Document Number:	601-00006-096
Title:	PFD Mandatory Service Bulletin to Address Air Data Performance Issues
Revision:	Rev 00
Date:	5 June 2008

This Service Bulletin provides important safety information concerning aircraft equipped with certain Avidyne EXP5000 Primary Flight Displays (PFDs) that may display incorrect altitude and airspeed information. It includes a process to positively identify Avidyne PFDs affected by these issues. Elements of this process include serial number comparison to identify PFDs that may

Figure 1: Airspeed indicator.

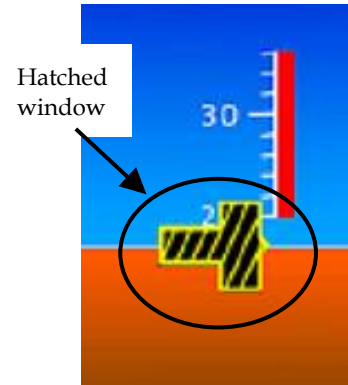
- a) Verify that the airspeed tape shows a yellow hatched window as in Figure 1.
 - b) Verify that there is an altitude tape reading.
 - c) Record the initial displayed altitude tape reading _____.

5. _____ Monitor the PFD while the AHRS completes its alignment. If during this period of time: a red X appears on the airspeed indicator; a non-zero airspeed is displayed; a red X reappears on the altimeter; **or** the difference between the altitude reading at any time and the initial altitude reading exceeds ± 20 feet, then the PFD is considered to be non-conforming.

- a. Record the altitude tape reading _____.
 - b. Verify that the recorded altitude tape reading is within ± 20 feet from its initial measurement.
 - c. Verify that the airspeed tape still shows a yellow hatched window as in Figure 1.
